Modification 2 – Nepean Hospital Redevelopment – Stage 2

State Significant Development Modification Assessment Report (SSD-16928008-Mod-2)

September 2024

Figure 2 | Extract from civil engineering drawings showing modified car parking layout at the eastern end of Barber Avenue (Source: ptc)

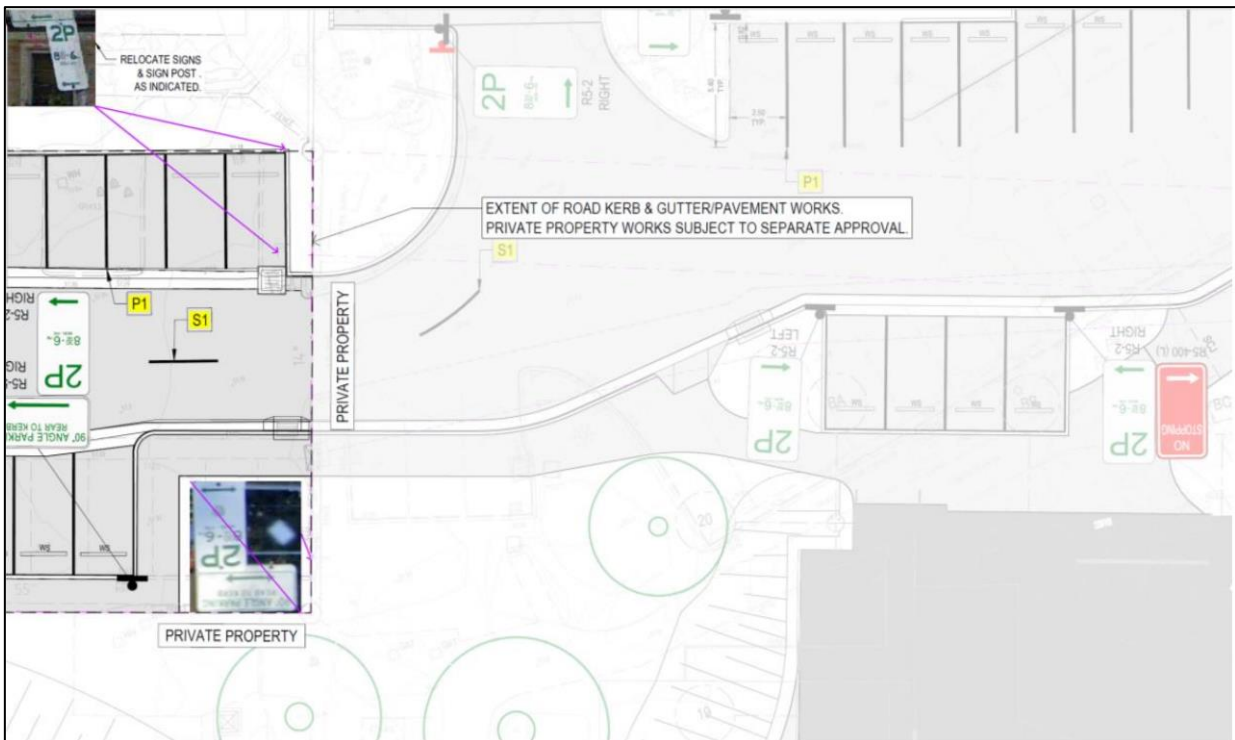
The modification application was accompanied by updated landscape and civil engineering drawings (see Figure 2), which have addressed part (a) of the above condition by removing parallel parking spaces within Barber Avenue. Only 90 degree car parking spaces are now proposed within the Barber Avenue road reserve and no parking spaces extend beyond the road reservation into hospital owned land.

The Department has reviewed the proposed revised car parking layout and considers that the amended design satisfies part (a) of condition B30. Furthermore, due to the reconfiguration of the car parking spaces, part (b) of condition B30 is now redundant. The Department is satisfied that condition B30 can therefore be deleted.

Figure 3 | Extract from the landscape plans showing removal of car parking spaces between the driveways (Source: Tract)

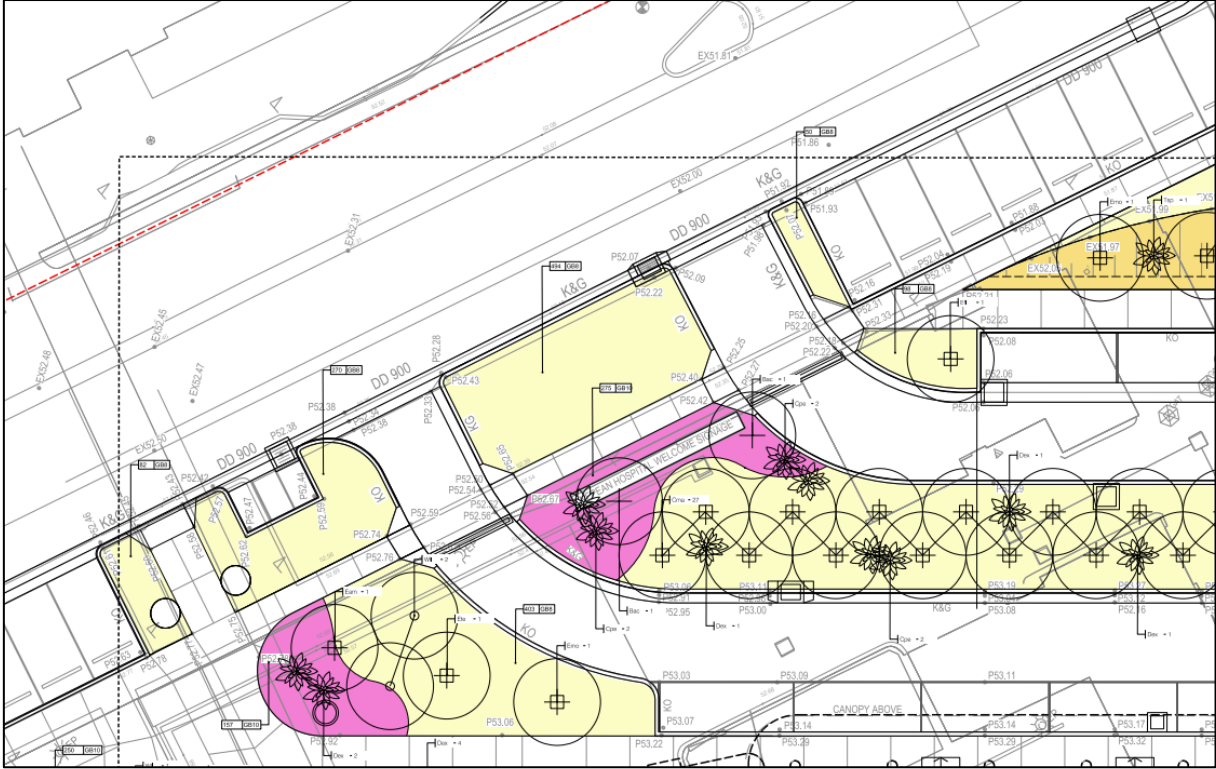
B32. Prior to the commencement of the relevant road works on Barber Avenue, the two parallel on-street parking spaces within Barber Avenue between the new hospital entry and exit driveways are to be redesigned and constructed as four 90 degree spaces.

The proposed modified development presents a layout which does not conform to the requirements of condition B32. The access driveways into the porte cochere have been shifted slightly to the west. The car parking spaces between the entry and exit driveways have been deleted altogether and replaced with turf (see Figure 3). The information submitted with the application states that no parking within the area between the driveways is sought for safety and visibility reasons for motorists and to segregate and differentiate the driveways from adjacent car parking. The Department supports this design change on the basis of the safety reasons

identified by the Applicant and further notes that the design changes made to the car parking design results in a total of 29 car parking spaces within Barber Avenue, compared to the previous 24 spaces, despite the inclusion of soft landscaping between the driveway access points.

The Department is therefore satisfied that condition B32 can be deleted.

Figure 4 | Extract from the landscape plan identifying turf and street tree (Source: Tract)

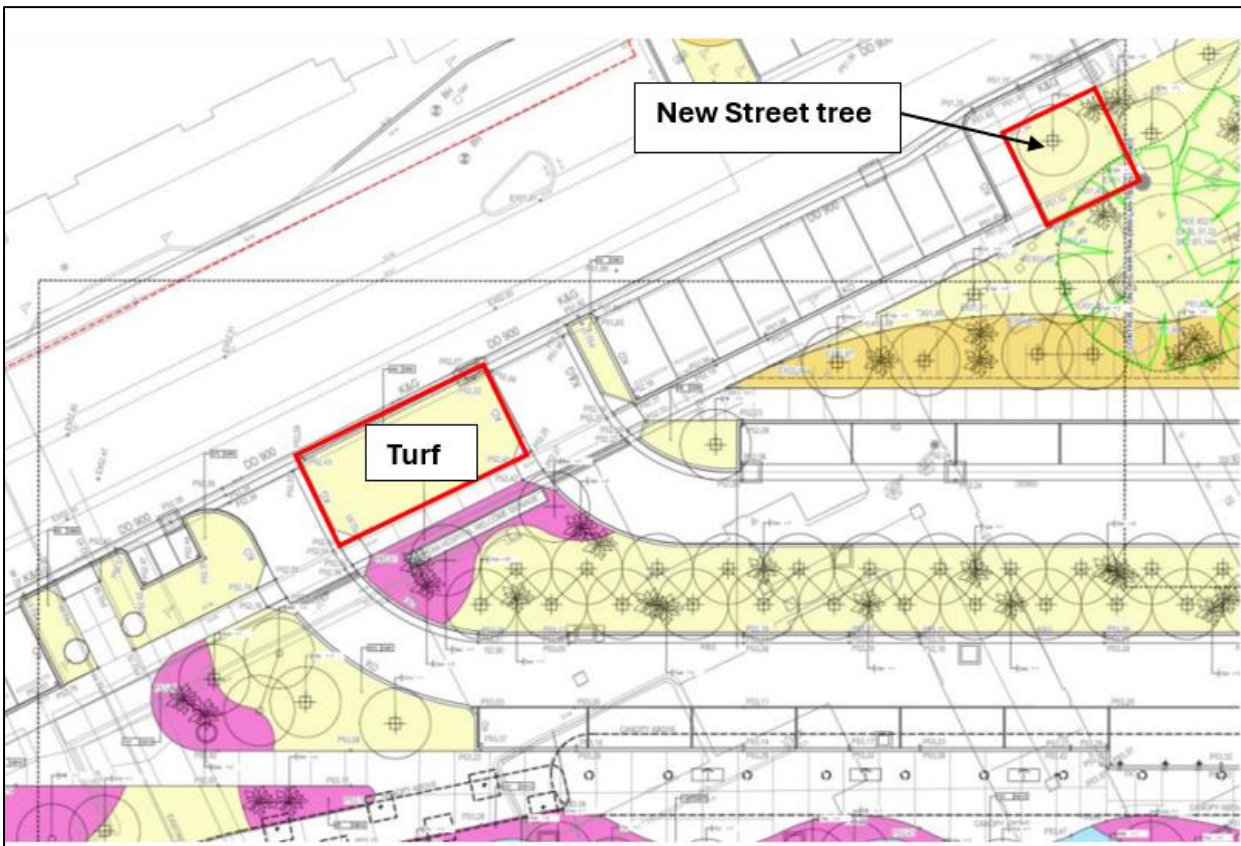
The proposed modified development incorporates landscaping design changes within the Barber Avenue road reserve and within the hospital site. Within the Barber Avenue road reserve, new landscaping in the form of turf is proposed between the redesigned entry and exit driveways and a street tree is also proposed at the termination of Barber Avenue (see Figure 4).

Amended landscape plans were provided with the RFI response to change the species of the street tree from *Eucalyptus moluccana* to *Melaleuca linarifolia*, at the request of Council. It is acknowledged that Council has sought the provision of further street trees in garden beds separating the Barber Avenue driveways. The Applicant has identified potential issues with visibility and sight lines of vehicles entering and egressing the porte cochere. The Department accepts this justification and considers there to be sufficient new trees planted across the balance of the site, noting that the subject modification application seeks to increase the number of new trees planted from 108 to 179.

Figure 5 | Location of tallwood tree removal shown circled (Source: Tract)

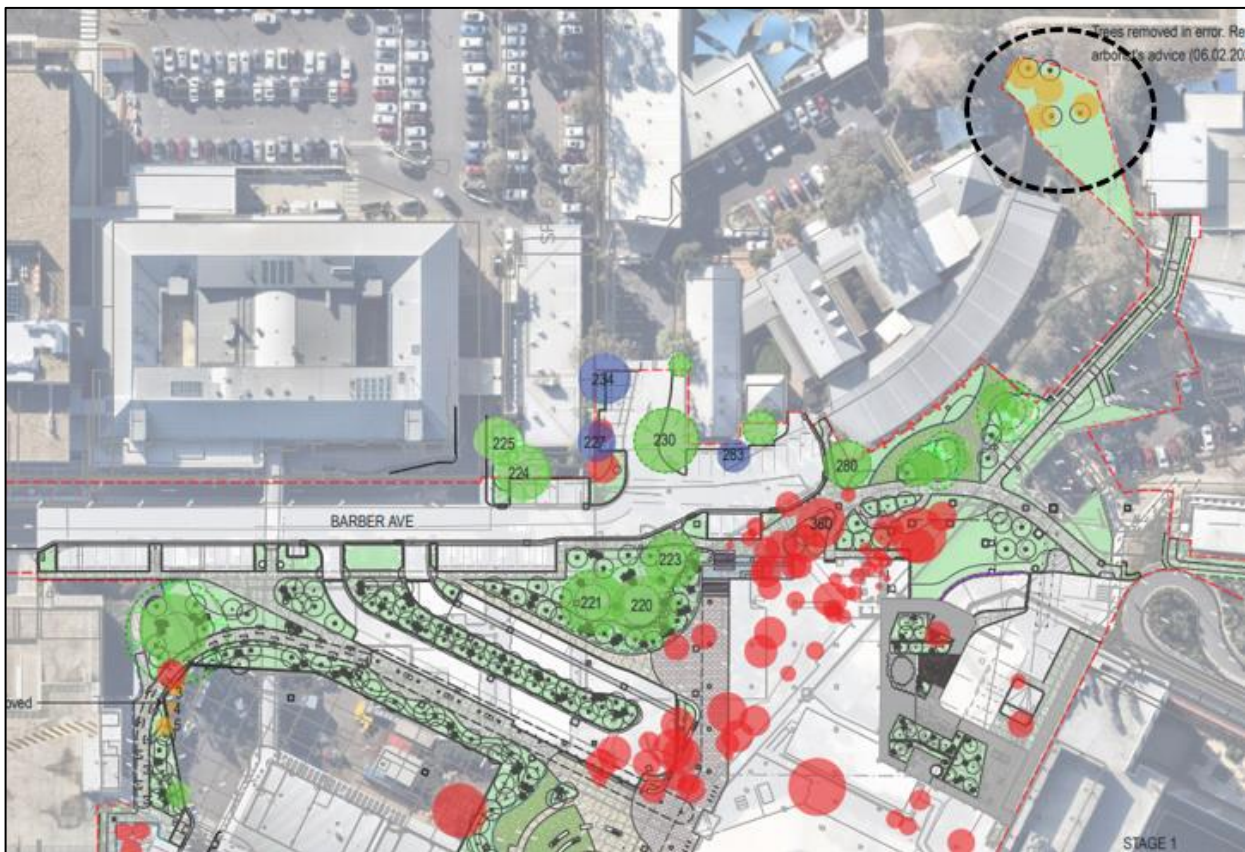
The modification application seeks consent for removal of four tallwood trees at the northern end of the site, adjacent to the Tresillian building (see Figure 5). The information provided with the modification application states that these trees were removed in error for the establishment of a site compound associated with the approved works. The application also seeks consent for removal of three newly planted Eucalyptus trees to the east of the existing multi-deck carpark, south of Barber Avenue, to accommodate expansion of the waste management area. The design changes made to the waste management area have resulted from the need to accommodate sufficient manoeuvring space for the largest vehicles to service the hospital (i.e. 13m garbage truck), ensuring that they are able to leave in a forward direction.

The Department considers the tree removal to be satisfactory in the circumstances for the following key reasons:

- the ecologist advice submitted with the application states the changes to the proposed/and already removed trees account for the additional loss of 300sqm of planted native vegetation. However, no additional credit offsets for the planted native

vegetation are required and the additional impacts are consistent with the current impacts assessed in the BDAR and are minor in nature and extent.

- the three Eucalyptus trees to the east of the existing multi-deck carpark proposed to be removed are in their infancy, having been planted in 2019. A garden bed will remain in this general area with new large native and small native canopy trees proposed to replacement the trees identified for removal.
- suitable replacement tree planting has been incorporated into the proposed modified development. The ecologist advice confirms that the selection of replacement tree planting is appropriate and conforms to the mitigation measures set out in the original BDAR.
- an updated planting schedule has been provided, including increased provision of new/offset canopy tree planting from the previous 108 new trees to 179 new trees. As a result, there will be a significant long-term improvement to the greening and spread of canopy trees across the campus.
